bq27500 EVM (HPA291 Rev. A) Errata

1 Summary

Figure 1. HPA291 Rev. A with incorrect silkscreen labels

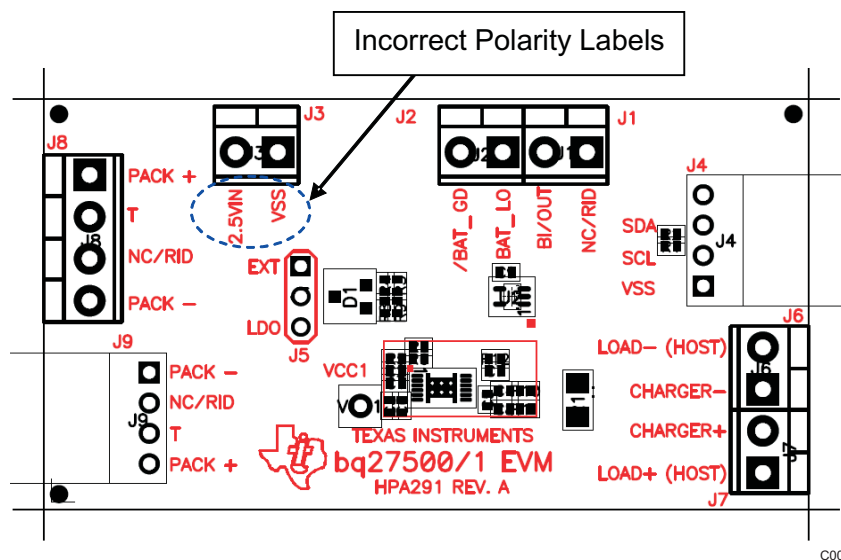
The HPA291 Rev. A boards have the **2.5VIN** and **VSS** labels interchanged at the J3 connector.

Connecting a 2.5V supply to this input with the polarities described per the actual silkscreen labels ([Figure 1](#)) will damage the bq27500EVM on the board.

If using the **2.5VIN** input with a 2.5 V regulated voltage and looking at the EVM board as in [Figure 1](#), ensure that the positive polarity is connected to the **right** connector of J3. The negative polarity or **VSS** of regulated voltage must be connected to the **left** connector of J3.
